U S NAVY RESPONSE TO THE U S EPA REGION I AND THE RHODE ISLAND  
DEPARTMENT OF ENVIRONMENTAL MANAGEMENT COMMENTS REGARDING THE  
DRAFT FEASIBILITY STUDY REPORT FOR SITE 7, TANK FARM 1, OPERABLE UNIT 13 (OU  
13) NS NEWPORT RI  
12/23/2014  
DEPARTMENT OF THE NAVY

**Navy Responses to Regulatory Agency Comments**  
**EPA Comments, October 28, 2014**  
**RIDEM Comments, November 17, 2014**

**Draft Feasibility Study Report for Site 7 – Tank Farm 1, OU 13**  
**NAVSTA Newport, RI**

**December 23, 2014**

**FIGURE 5**  
**TRANSFORMER VAULT 3**  
**SAMPLE LOCATION MAP**

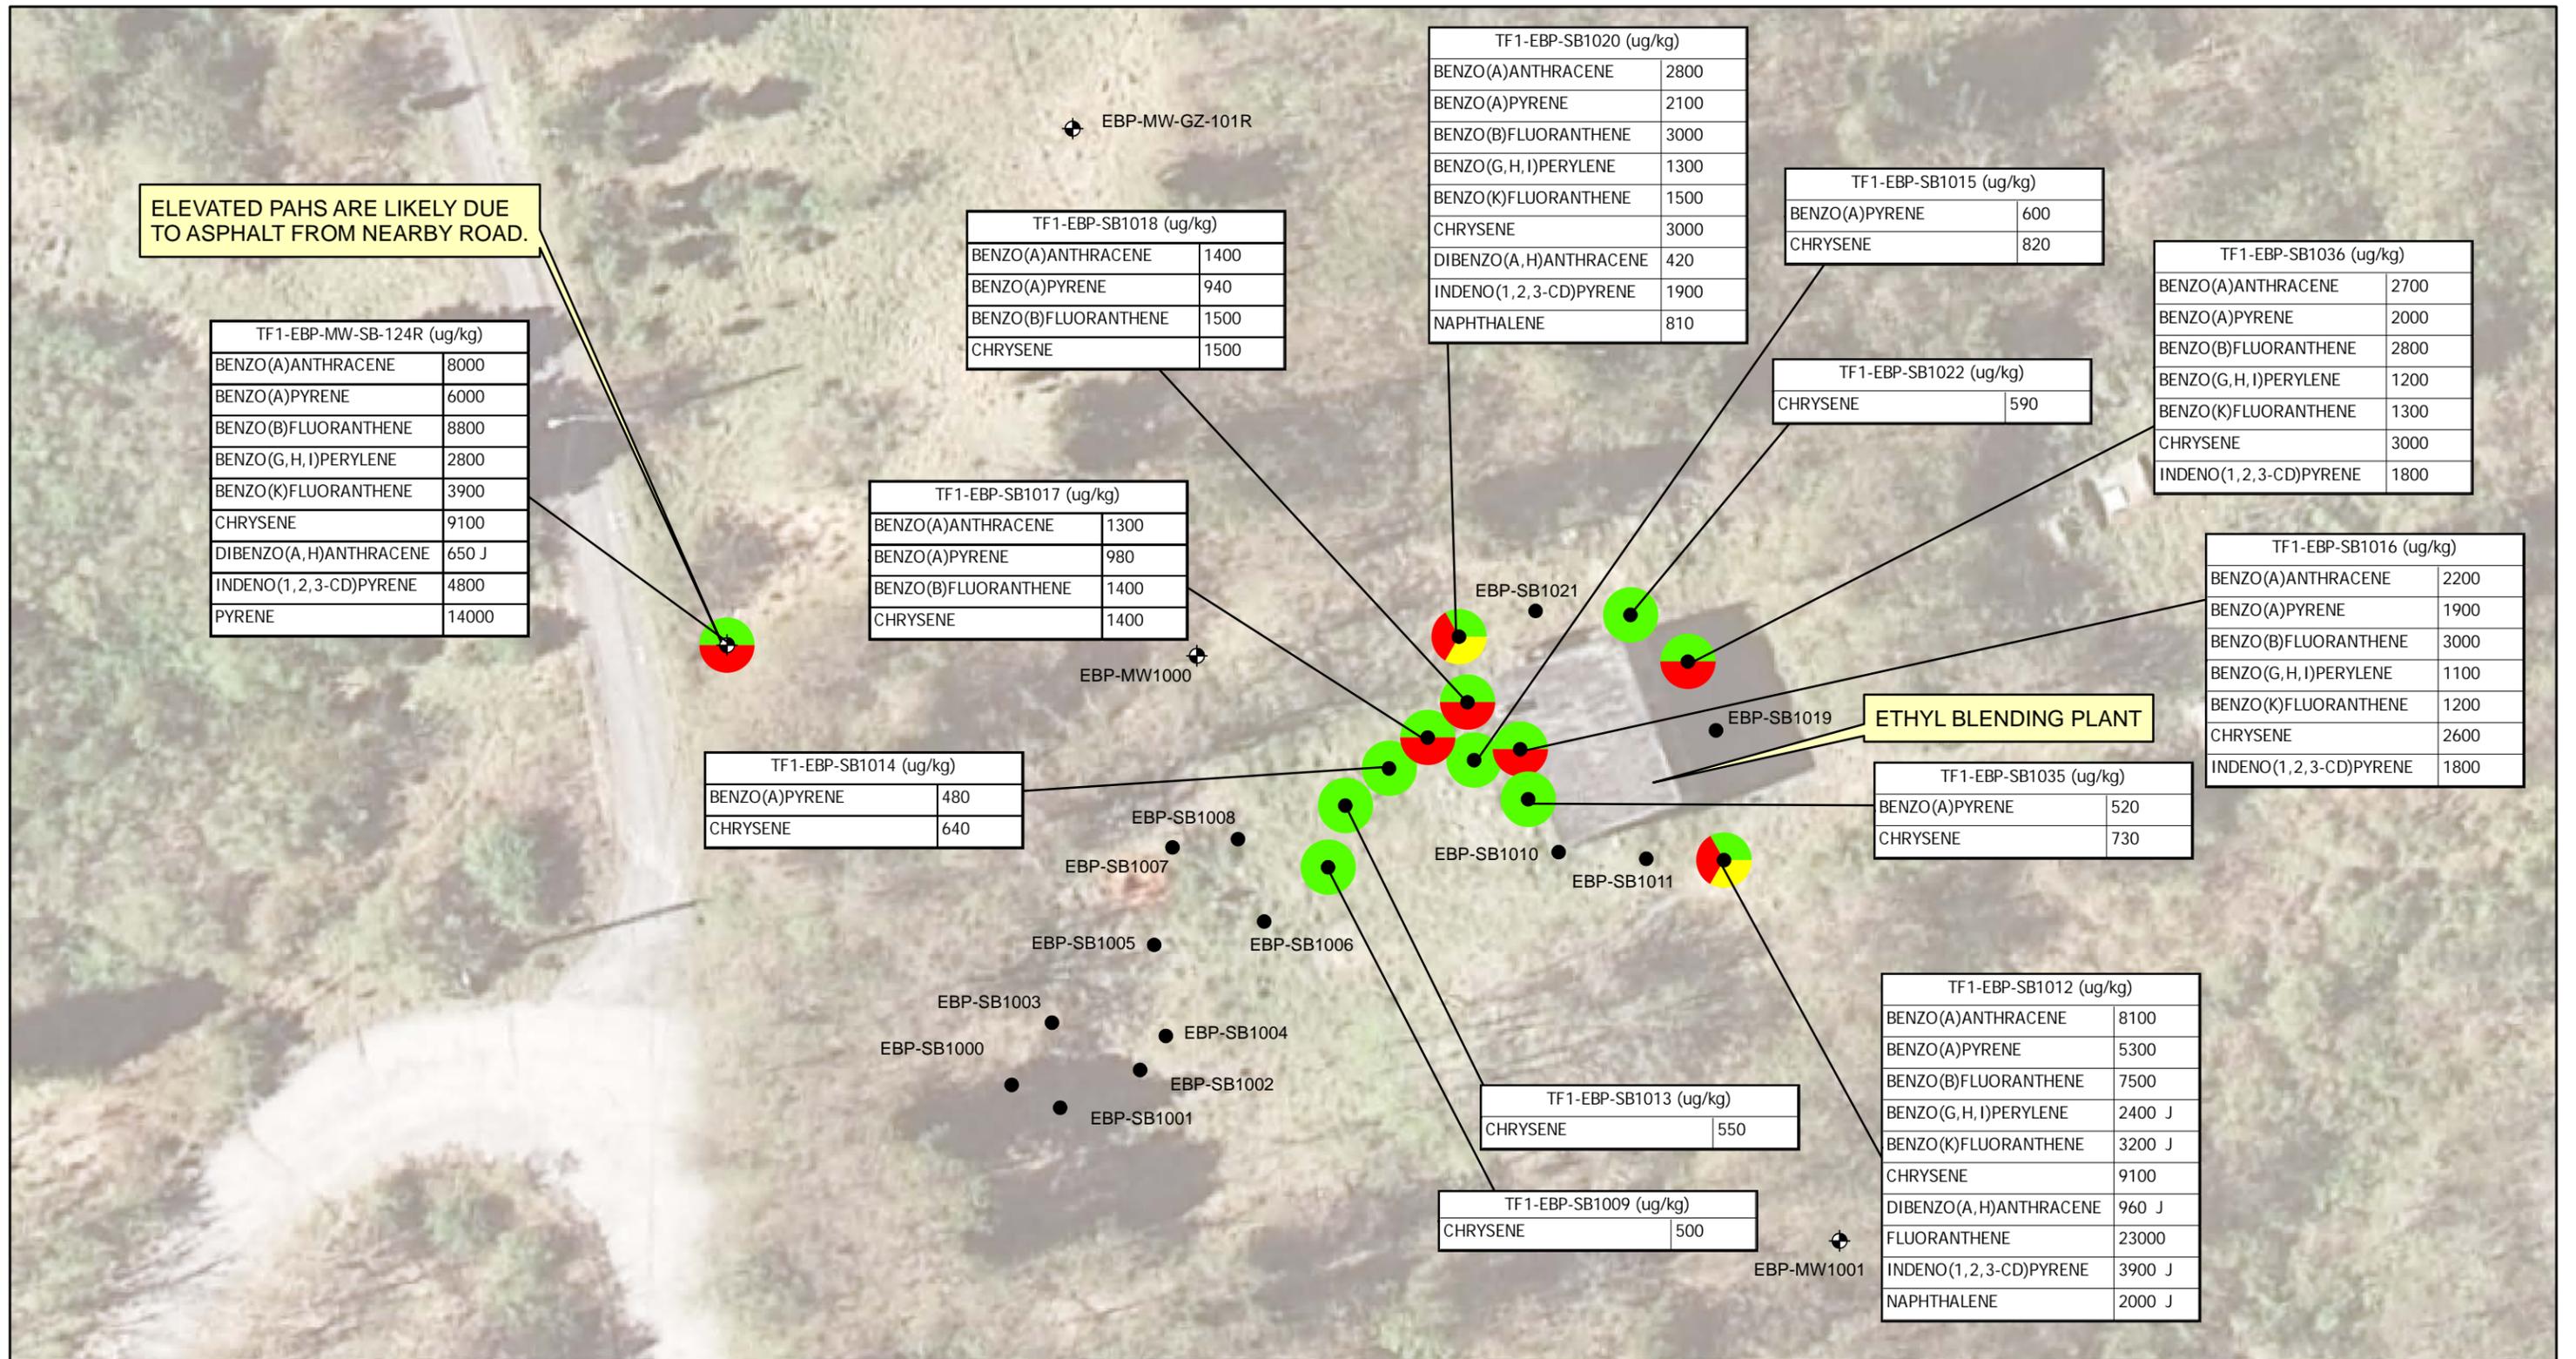
***EPA Specific Comment 95:*** Figure 5 - Please add the Shaw sample to this figure.

***RIDEM General Comment 4:*** *Sample results from all previous investigations, including the 2010 investigation, should be presented consistently throughout the text, tables, and figures of the report, or justification for not doing so should be provided for completeness. For example, RIDEM notes that samples collected in 2010 from sample locations TV2 and TV3 are discussed in the report text and the results are provided in tables included in Appendix A; however, only the sample collected in 2010 from TV2 is presented on the associated Figure 4, and the sample collected in 2010 from TV3 is not presented in the associated Figure 5. In addition, the results of the 2010 sampling at the EBP are only discussed in text.*

***RIDEM Specific Comment 68:*** *Figure 5, Transformer Vault 3 Sample Location Map - Please add the location of TF1-EV2-N.*

**Response:** Figure 5 has been revised to include the 2010 sample location and is attached. The 2010 sample locations collected at the EBP were not added to the figures or tables since the samples were only analyzed for TPH and GRO, which are not COCs in this FS. Note that Appendix A has been removed as described in the responses to EPA Specific Comments 99 and 100. Surface soil sample data collected at the Transformer Vaults during the 2010 sampling event is included on Table 2-6 (former Table 2-5).

**FIGURE 6**  
**SURFACE SOILS EXCEEDING PRGs**  
**FOR PAHs**  
**ETHYL BLENDING PLANT**  
**TANK FARM 1 (SITE 7)**  
**NAVSTA NEWPORT, RHODE ISLAND**

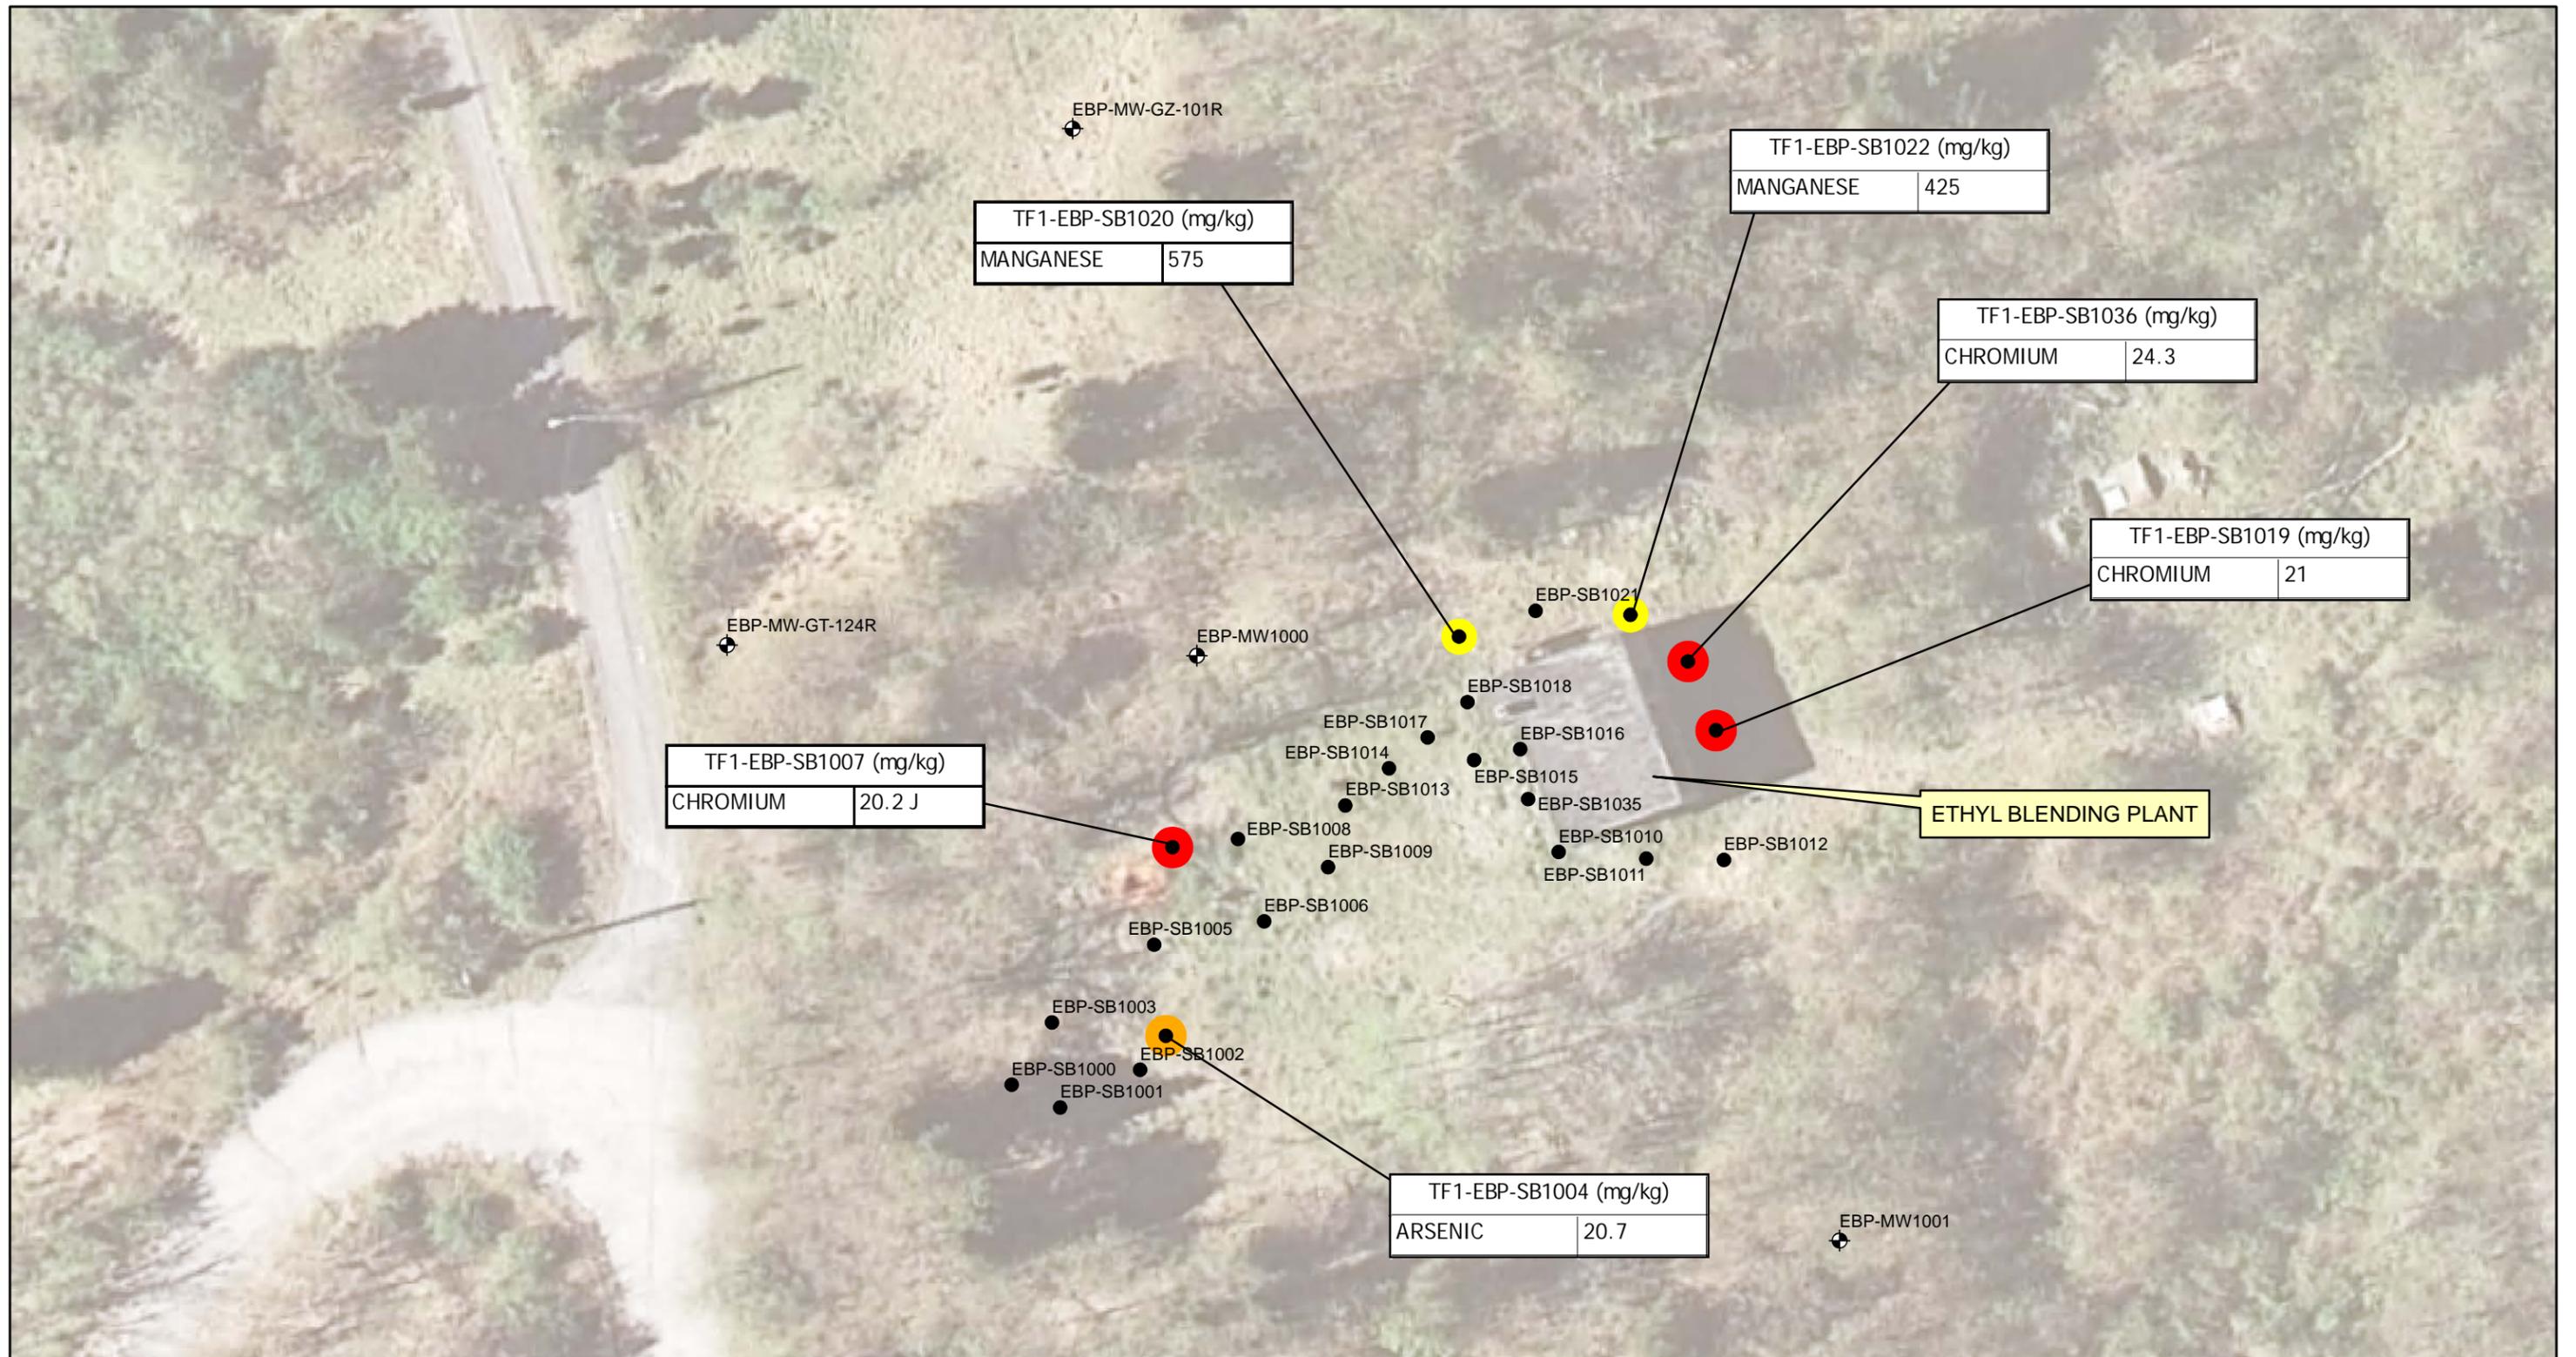
**EPA General Comment 4:** *Include a tag map that depicts where PRGs are exceeded.*

**Response:** Analytes and corresponding concentrations for soil samples that exceeded PRGs have been added to Figures 6, 7, 9, and 10. The revised figures are attached.

**FIGURE 7**  
**SURFACE SOILS EXCEEDING PRGs FOR METALS**  
**ETHYL BLENDING PLANT**

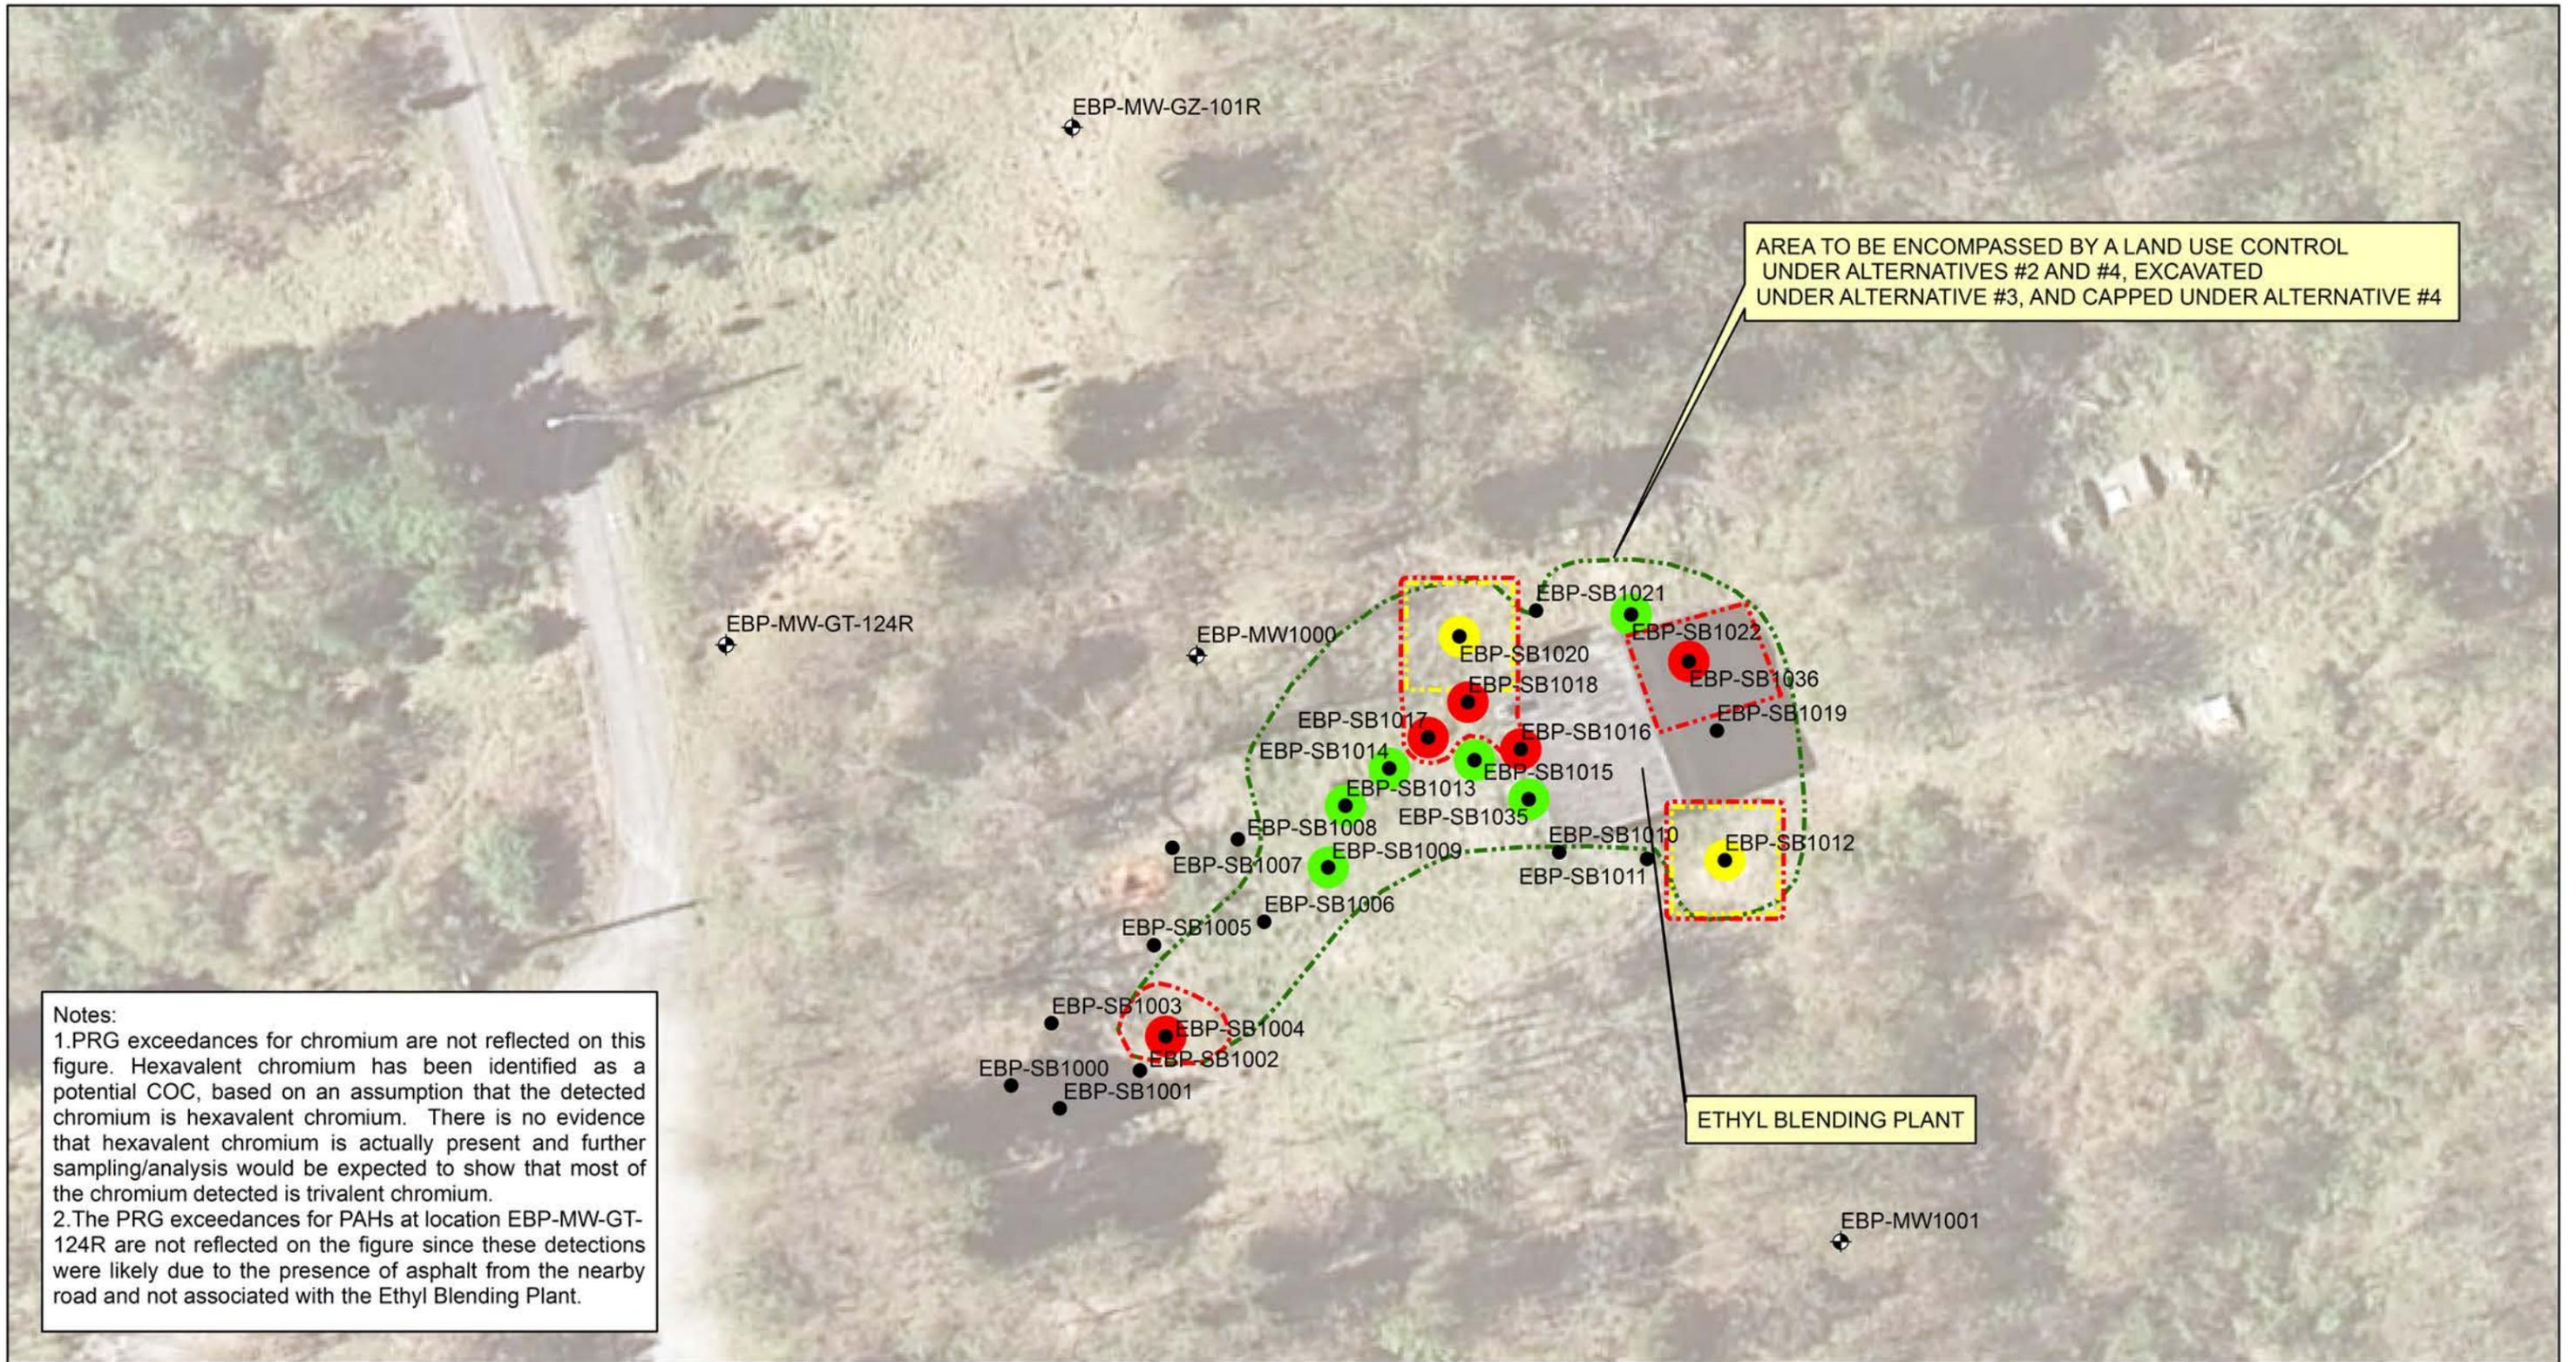
***EPA Specific Comment 96:*** Figure 7 - Provide the missing text associated with the asterisk.
